SB-0034.

Calculation C-CSS-099.20-054, Revision 0:

Figure 1: Strains and demands for a section under large compression demand and moment

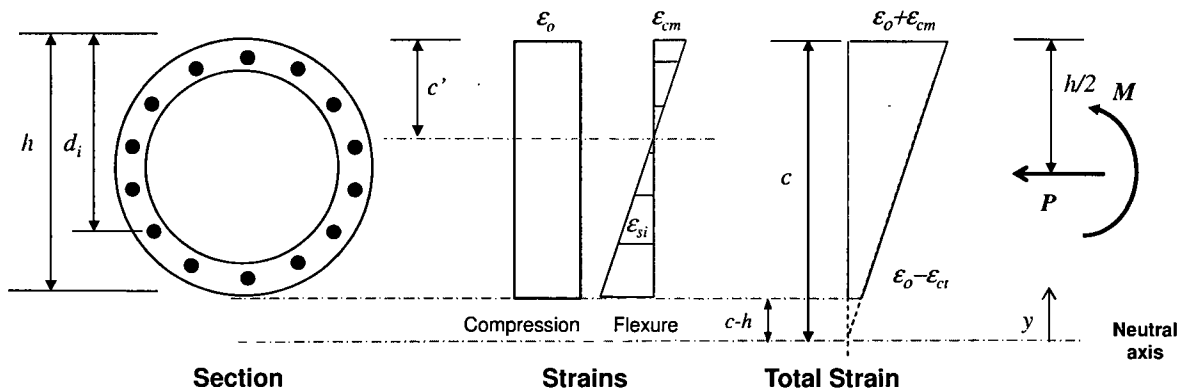
Page 9: At the top of the page, equation  $y = \text{Max}(0, c-h)$

Please explain how this is used in the calculation. Given that  $c$  is always less than  $h$ , the above equation will always return  $y = 0$ .

Please refer to Figure 1 below for a graphical explanation of the meaning of  $y$ . As can be seen, the variable  $y$  is always measured from the location of the neutral axis, which lies outside of the concrete cross section only when the compression force  $P$  is very large (i.e., for demands nearing the compressive capacity of the section). Therefore, for a section under the large compression demand shown in figure 1, the internal compressive force  $C$  is obtain by integrating the compressive stress between  $(c-h)$  and  $c$ .
